HISTORIC LANDMARK COMMISSION
PERMITS IN NATIONAL REGISTER HISTORIC DISTRICTS
FEBRUARY 25, 2019
NRD-2019-0011
Old West Austin National Register Historic District
3005 Funston Street

Construct a new single-family residence.

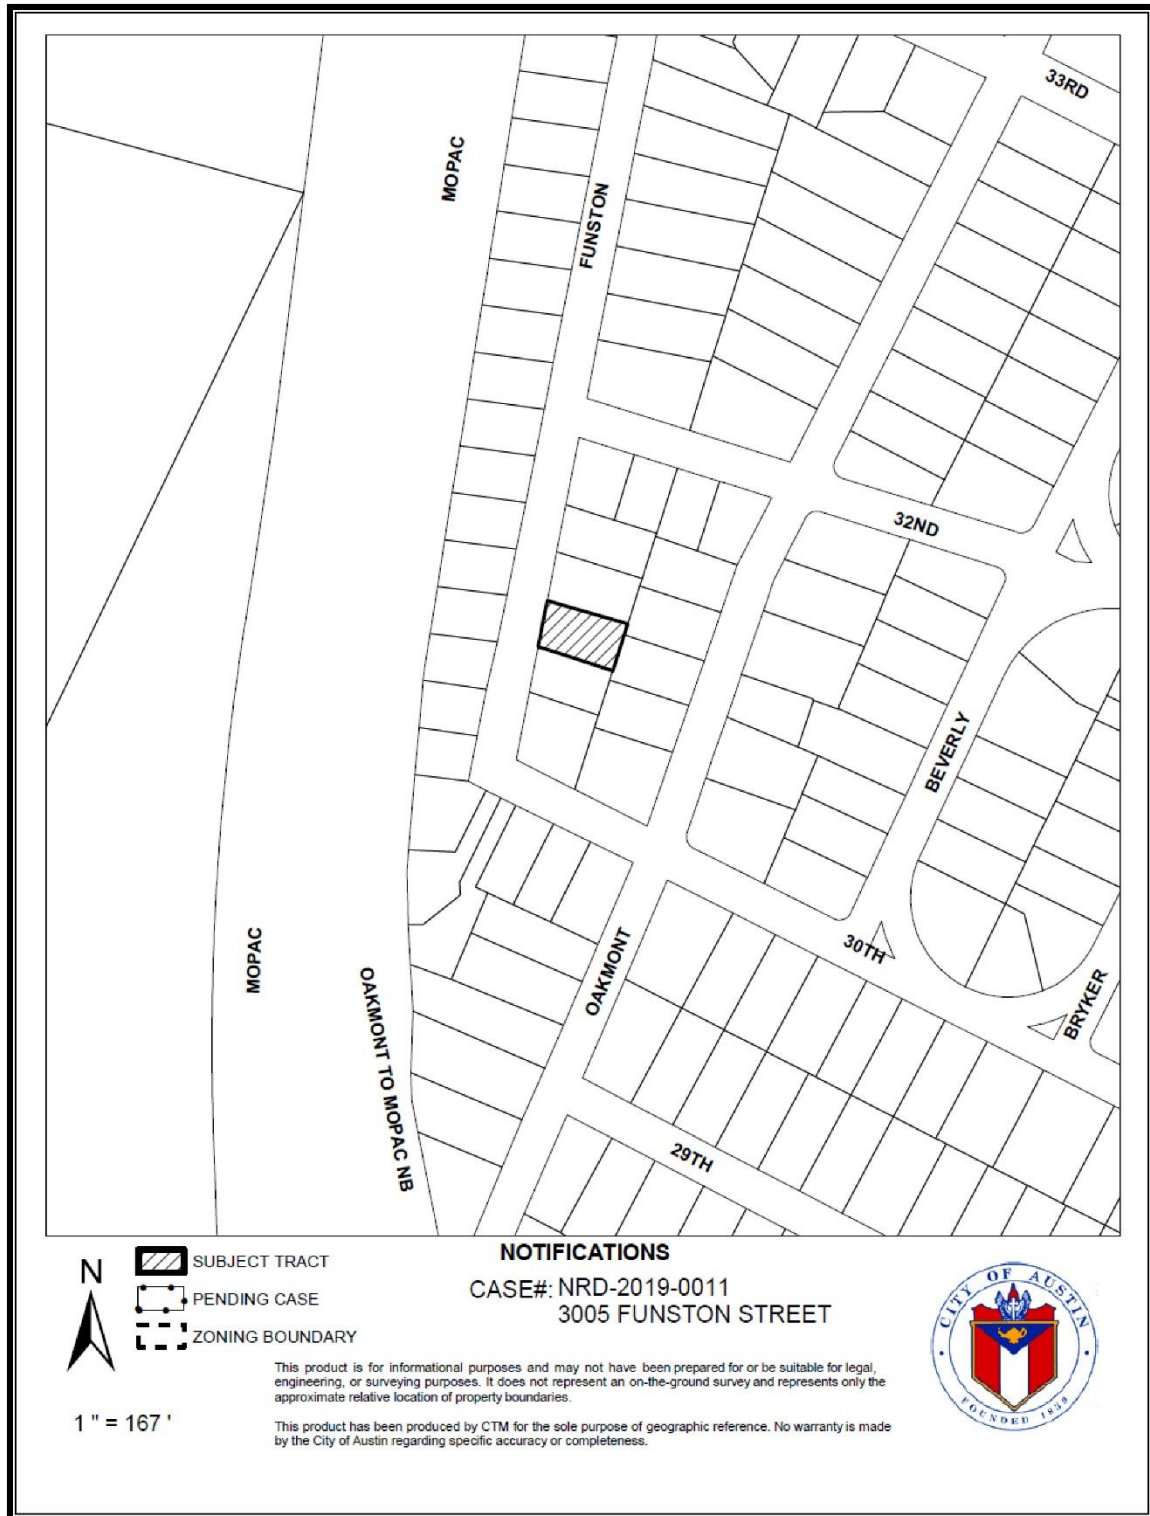
The proposed building is appropriately differentiated from the historic houses by its neo-traditional style and mixed materials. The Colonial Revival elements of the building are more formal than the historic-age Minimal Traditional homes on the street. Though the proposed structure is much larger and more complex in design than the simple single-story historic-age houses in the neighborhood, it is similar in scale to other contemporary structures on the street, including the building next door and several across the street.

Set the 2nd-floor porch back from the main façade to break up the massing of the proposed design. Add a half-wall to the porch and clad with siding to create further visual recession of the garage.

Release the application as proposed, as the applicant has implemented the Committee's recommendations. Encourage the applicant to consider further simplification of the house's main façade and roof form to enhance cohesion with the smaller historic-age Minimal Traditional homes that remain on the streetscape.
